**Our Case Number:** ABP-314724-22

**Re:** Railway (Metrolink - Estuary to Charlemont via Dublin Airport) Order [2022]  
Metrolink. Estuary through Swords, Dublin Airport, Ballymun, Glasnevin and City Centre to Charlemont, Co. Dublin

## **RE: MetroLink Railway Order (Case: 314724)**

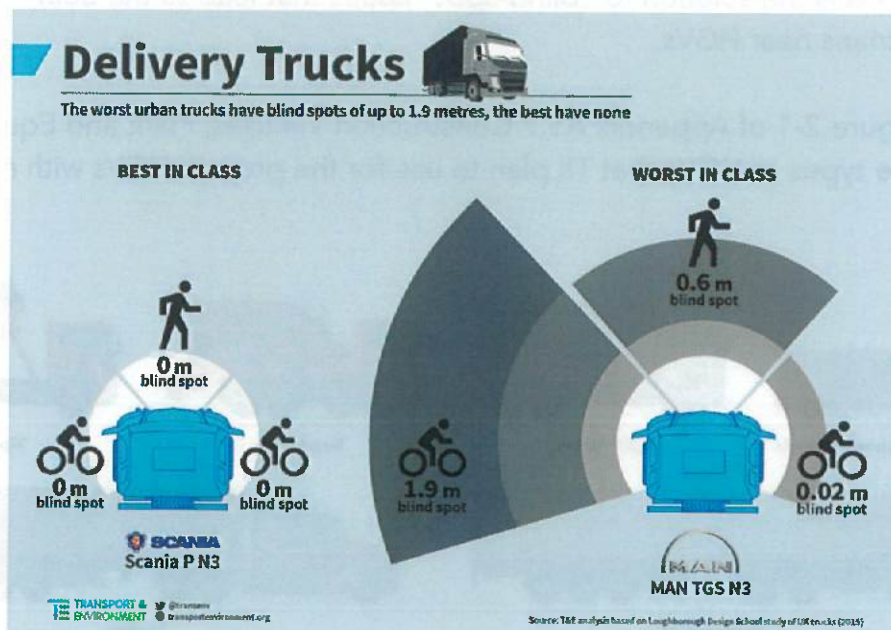
Below is Figure 2-1 of Appendix A5.7 Construction Vehicles, Plant and Equipment showing the types of HGVs that TII plan to use for the project. HGVs with no direct vision.

TII's proposed mitigation measures are out of date with the best scientific evidence on how to mitigate the risk to vulnerable road users posed by HGVs. There are standards from other projects that they should implement for MetroLink.

We request that ABP ask TII for further information on how to mitigate this risk, including how cycling will be facilitated safely around construction sites. We also ask ABP to require conditions on HGVs to use the latest technology improvements to reduce the risks of blind spots.
